December 2022 Changes to Proposed Development at 109 Palmerston St Perth

SUMMARY

Figure 4. Overshadowing of 107 Palmerston St. caused by the Fig tree in Robertson Park June 3, 2022.

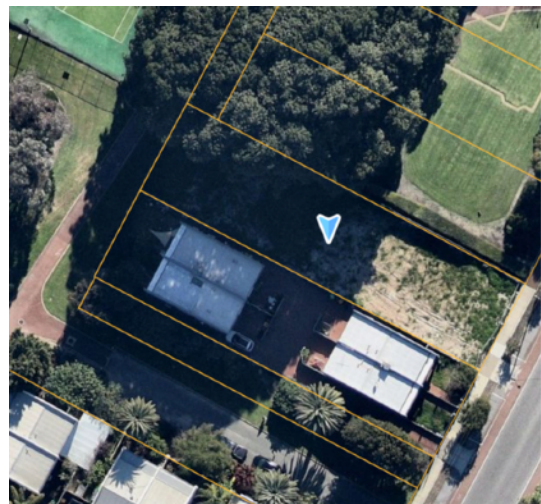
e) Clause 5.4.2 of the R Codes in relation to Solar Access for Adjoining Sites. The development has not been appropriately designed to protect the neighbouring property's (No. 107 Palmerston Street) access to direct sunlight to outdoor living areas and major openings, and would adversely affect the amenity of the neighbouring property;

- The site is heavily overshadowed from the North by the neighbouring fig tree, therefore solar access from the North is not possible for the rear neighbouring homes or the courtyard between the homes. Figure 4 shows the overshadowing caused by the tree taken on June 3, 2022.

- All the North facing windows on the rear neighbouring unit are overshadowed by the Fig tree in Robertson Park (Figure 4). Our development will not cast any additional overshadowing on the rear unit.

Figure 5. Location of neighbouring property windows in relation to the proposed development. The yellow circle shows the only major opening with existing North facing solar access.

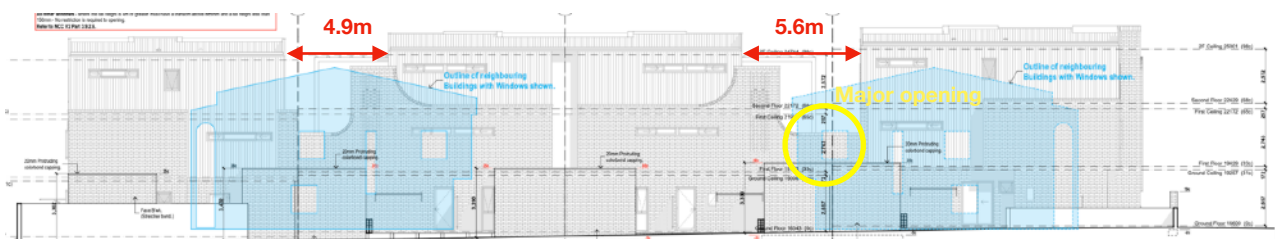
b) Clause 5.1.3 of the R Codes in relation to Lot Boundary Setbacks. The proposed development would adversely affect the amenity of the neighbouring property at No. 107 Palmerston Street because it would not maintain adequate access to direct sun into buildings and open spaces, and the proposed development has not been appropriately set back from the south western lot boundary nor designed to reduce the impacts of building bulk and scale;

- Our proposal has maintained the flow of air and dappled light to the neighbouring properties by providing meaningful spacing between the units. These have been aligned with the windows of the neighbouring property, to decrease the impact of bulk and scale (Figure 5). Hit and miss brickwork feature walls to parts of this area provide visual interest and privacy.

- The front RHS unit has one major opening facing North. (The other large window on the North is located on the staircase landing and is therefore not a major opening). We have preserved North facing solar access to the major opening of the front unit with a 5.6m wide gap between our units which is aligned with the window in question (Figure 5.) This room also has an additional window facing North West so it will have ample solar access during various times of the day.
